TO: DEVELOPMENT REVIEW BOARD      DATE: 6/21/90  
FROM: PLANNING & ZONING MANAGER  
SUBJECT: CASE 99-DR-89#2

REQUEST: Approve Site Plan & Elevations for a Golf Clubhouse  
PROJECT NAME: Four Seasons Clubhouse  
LOCATION: 100th Street & Dynamite Boulevard

STAFF RECOMMENDATION: APPROVE subject to the attached stipulations.

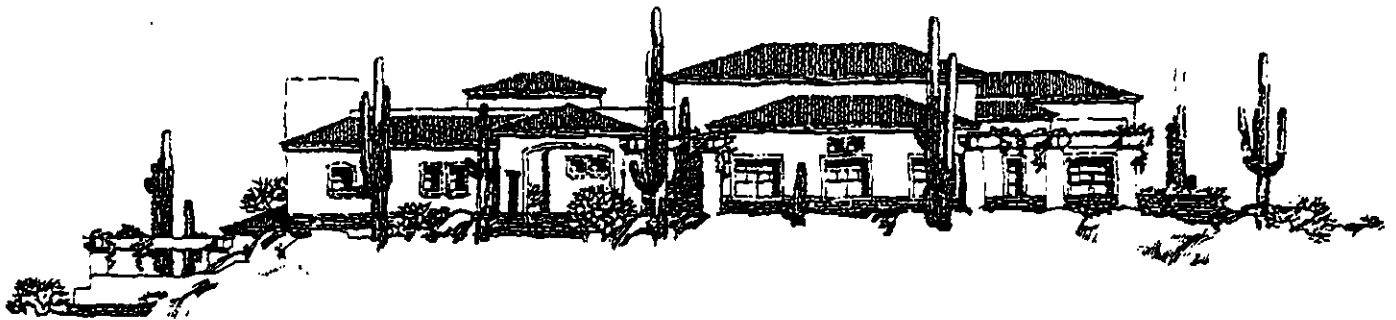
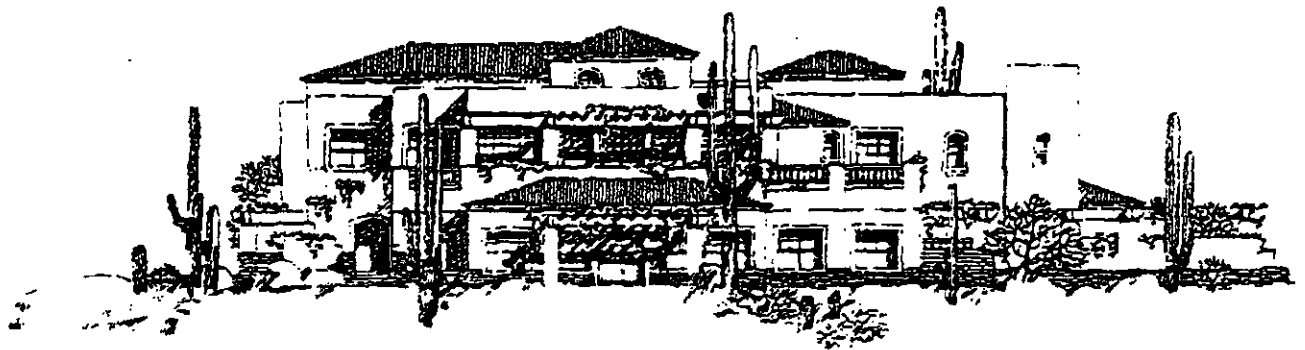
The building design has been softened into a more generic Mediterranean character. Arizona sandstone will still be used as a foundation material. The walls will now be smooth, rounded stucco painted various shades of beiges and terra cottas. This use of different colors on different wall planes has been used in recent Mexican designs. Variegated tile on hip roofs tops towers and porches, and stained wood is used on porticos, balustrades and windows. The building form is broken into a multitude of planes, niches, patios, porches and towers. The result is an almost "village" look. The new character is less formidable than the prior design.

1. All rooftop mechanical shall be completely screened by parapet walls or within roof structure.
2. All ground mounted mechanical shall be completely screened by screen walls with color and texture to match the building.
3. Exterior building colors shall be muted earth tones and shall be reviewed in the field for Development Review Board approval.

# Landscape/Materials List/ Lighting

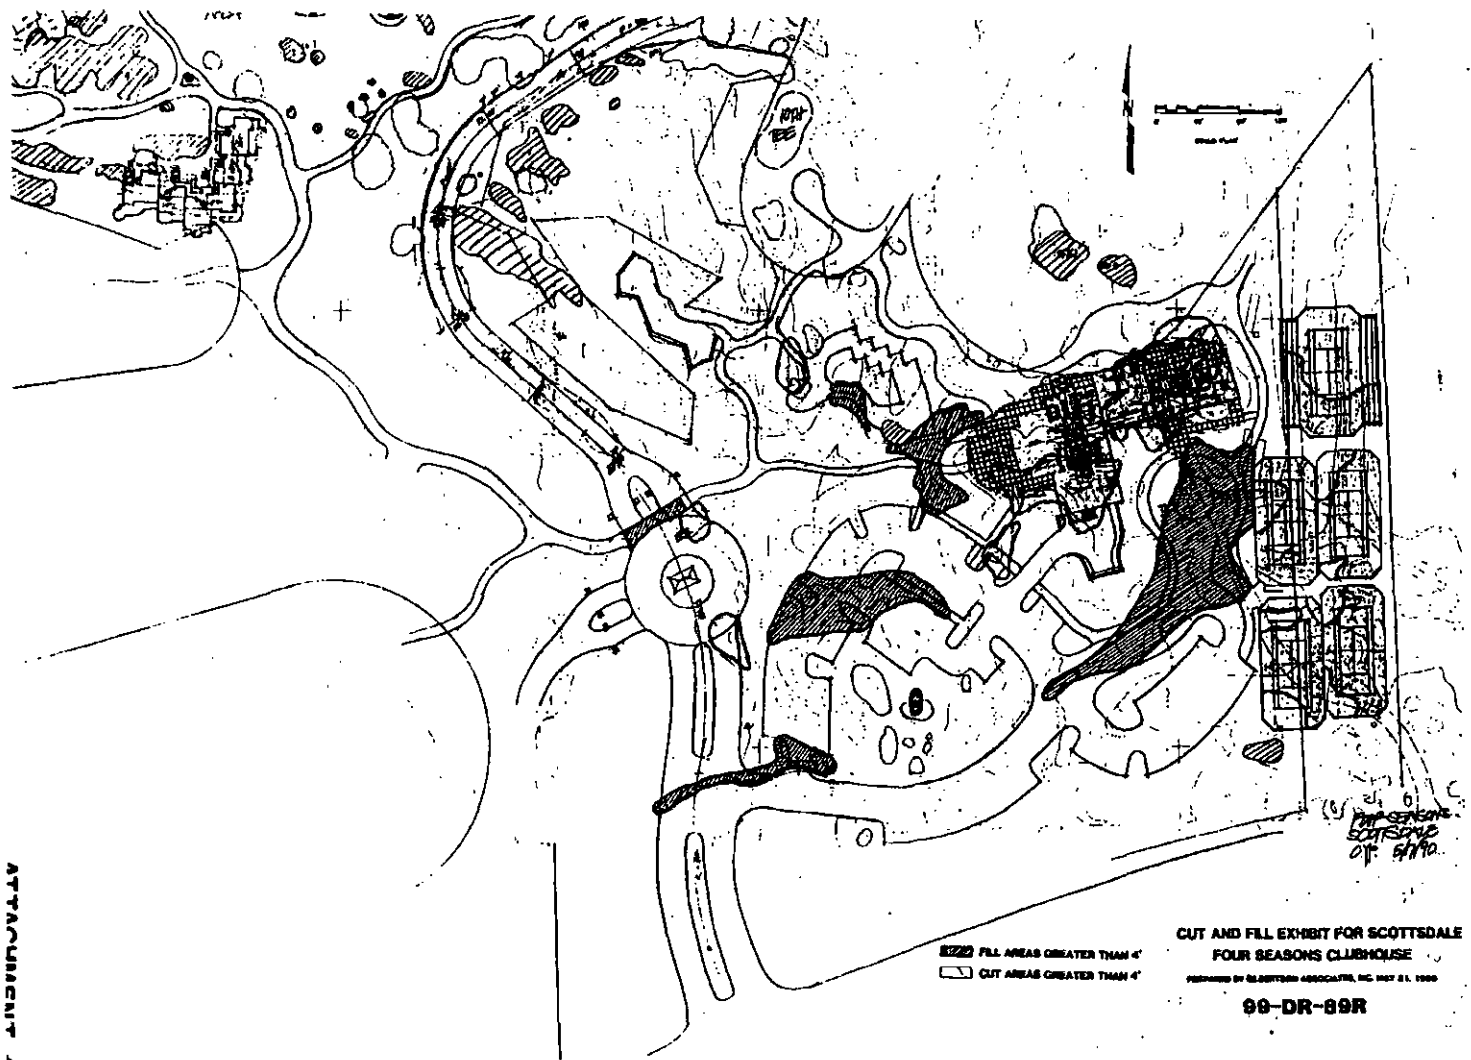
The parking area has been designed to flow with the natural form of the land. Boulders features and major vegetation will be protected. Lighting will be cut off fixtures no taller than 15 feet.

The landscape concept remains the same as in the last proposal.

1. Provide plans indicating all on-site lighting and lighting fixtures (re: diffusing, standards, glare, height, etc.).
2. All pole mounted lighting shall be a maximum of 15 feet in height.
